Continental Manor

RE: Continental Village
Route 300, S.H. 9457
Town of New Windsor

Subject: Specifications for Road and Parking
Lot Sections on Continental Manor Plan

CONTINENTAL MANOR

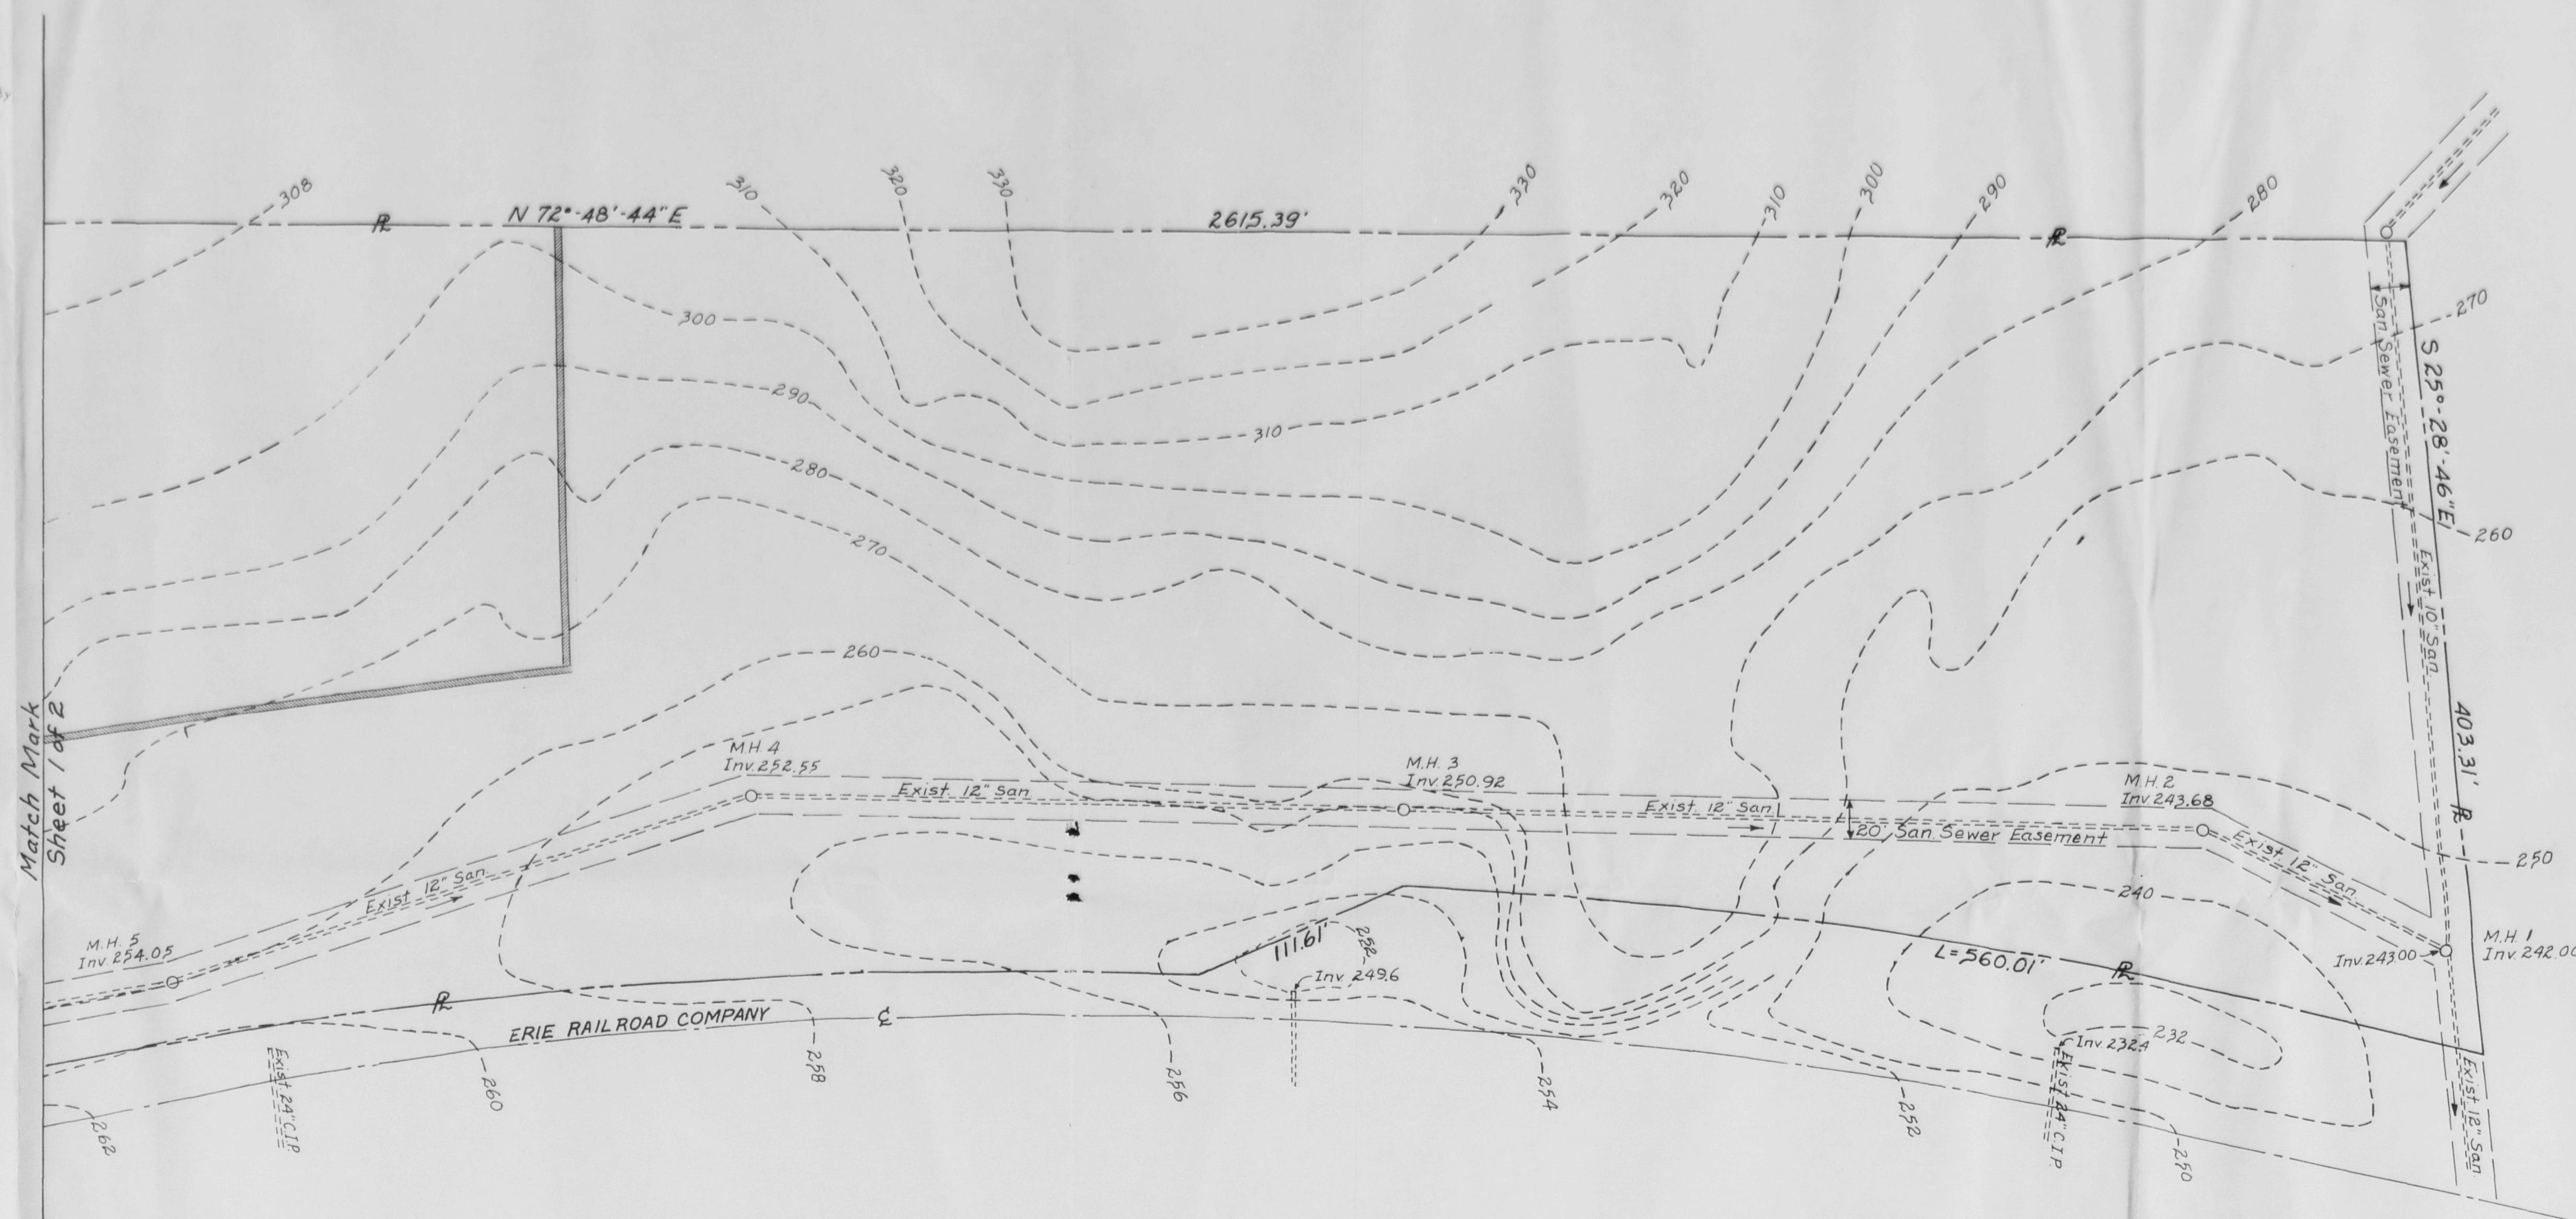
This is to inform you that the plans for this project dated 1978 showing the proposed work on Temple Hill Road does not meet this Departments standards.

As you are aware, this section of highway is under a Design Contract and is going to bid for reconstruction in late 1986. Therefore, it is our position that any improvements to be made, as needed, be part of this work.

TYPICAL DIVIDED ROADWAY SECTION

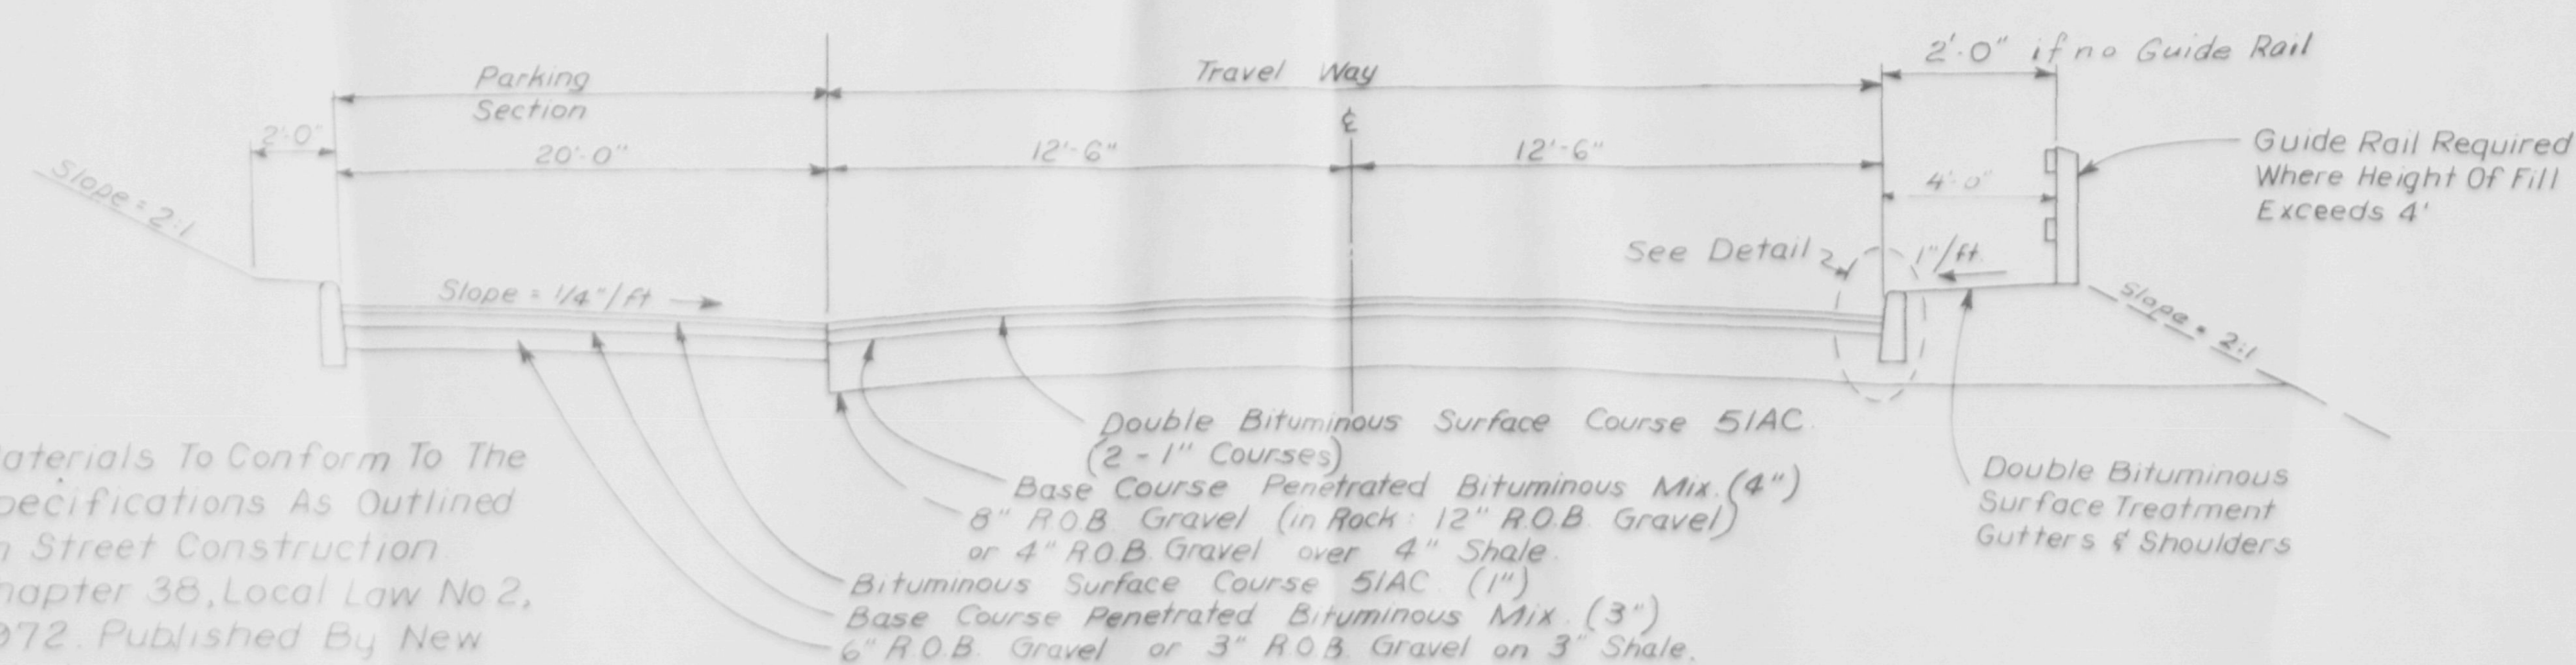
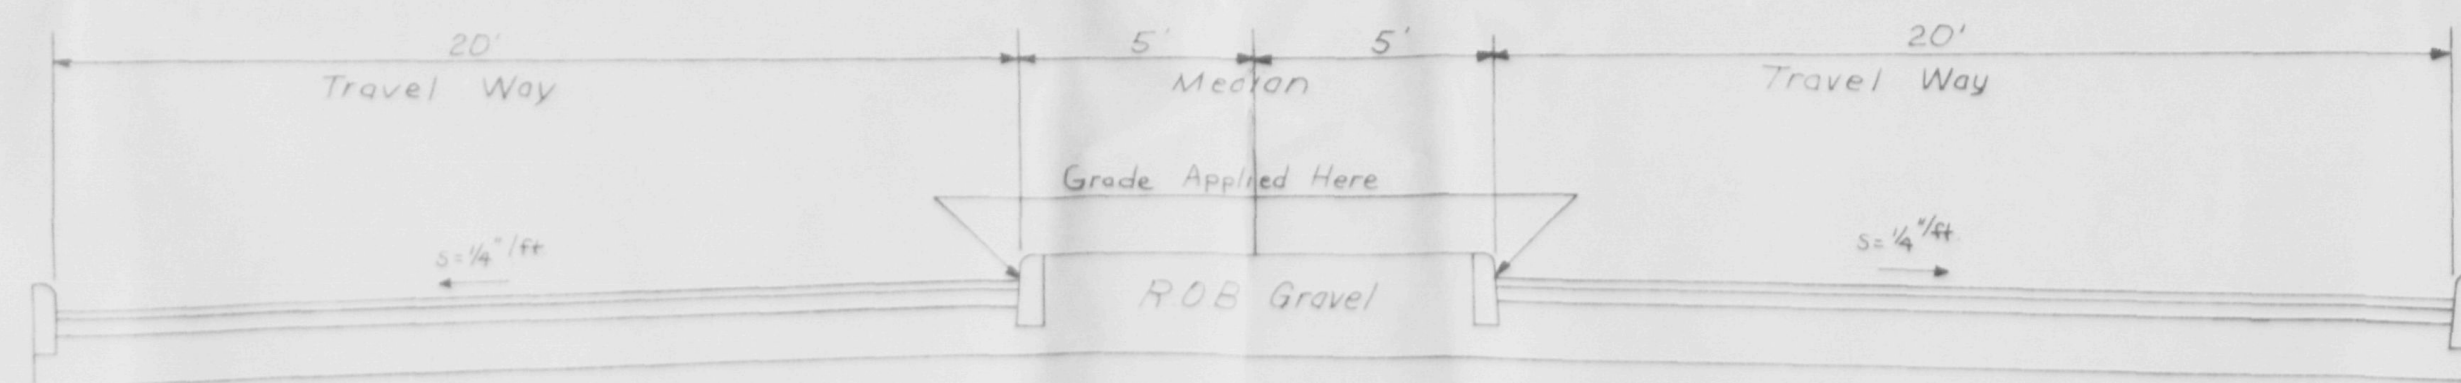
The typical divided roadway section and the interior roadway section on the planning board approval plans for Continental Manor, July 19, 1977, Page 2 of 2 should be changed.

The geometry of both sections stay the same, however, the typical section should read as follows:

Road:

- 2" Top
- 4" Stabilized Base
- 5" Crushed Stone or Shale

In addition, a parking lot specification should be added:

Parking Lot:

- 1" Top
- 3" Stabilized base
- 5" Crushed Stone or Shale
